East End Park and Pool

East End Park and Pool is large neighborhood park that provides a pool, playground, three ballfields, soccer field and picnic area. The main issues at this park are not properly designed parking spaces, slopes too steep, elements within reach ranges, door opening forces too high, need for proper benches in locker-room and in the park, routes to bleachers, player benches and entrance to fields, and providing the proper number of accessible picnic tables. It would be recommended to make Ballfields #2 and #3 accessible just with their close location to parking. **Please Note:** When a **UD** is indicated, this is a Universal Design (**UD**) recommendation to enhance accessibility. The **UD** recommendation is not required to meet the minimum accessibility standards but it would be encouraged.

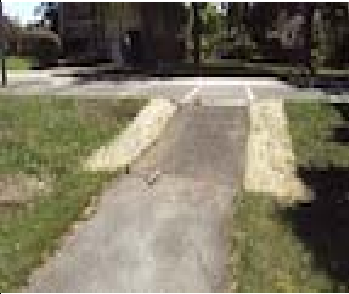
Photo	Barrier	ADAAG/IAC	Solution	Priority	By Whom	Projected Cost	Projected Date	Action Taken
	There is a trash can along the route to field #1 that is located in the grass.	Proposed Outdoor Developed Areas Guidelines 1011	Trash Can Recommendation: Locate trash cans on an accessible route as part of your regular policy. For a forward approach provide a trash can within 24" and a minimum clear ground space of 36" by 48" or for a side approach provide a trash can within 24" and a minimum clear ground space of 30" by 60".			\$50	2012	Moved trash can 5/2012
	Cross slope to Field #2 is too steep at 2.6% to 4.2% for 16'.	ADAAG 403.3	Remove and regrade section to provide a cross slope no greater than 2%.			\$525	2020	
	Field #2 south bleachers do not provide companion seating.	ADAAG 221.2.1 & 802.1	Provide the appropriate number of wheelchair spaces (30" X 48" space) per total number of seats (\$250 per space) with a slope of 2% in all directions.			\$500	2020

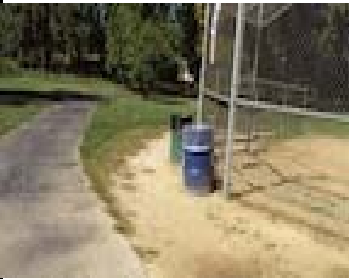
Field # 2 there is no accessible route to the west entrance to the field for 11'.	ADAAG 221.2.1.4 & 802.1	Provide an accessible route that is a minimum 36" wide with running slopes no steeper than 5% and cross slopes no steeper than 2%.			\$375	2020

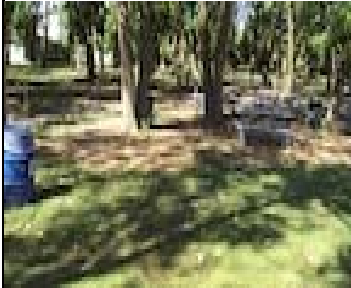
Photo	Barrier	ADAAG/IAC	Solution	Priority	By Whom	Projected Cost	Projected Date	Action Taken
	Field #2 there is no accessible route or companion seating to the west player bench for 11'.	ADAAG 221.2.1.4 & 802.1	Provide at least one wheelchair space on an accessible route that has a 36" by 48" clear floor space from the front or rear or provide a 36" by 60" clear floor space for a side approach.			\$500	2020	
	No accessible parking is provided to ball field #3. There is a 7' 2" striped area at the walkway that could be widened to 8' and become an access aisle.	IAC 400.310(c)	Provide one accessible parking space with a access aisle a minimum of 96" plus a sign with the International Symbol of Accessibility and a fine sign of \$250 at the head of the parking space. The parking space and access aisle should be no steeper than 2% in all directions. Locate the accessible parking space on the shortest accessible route.			\$750	2020
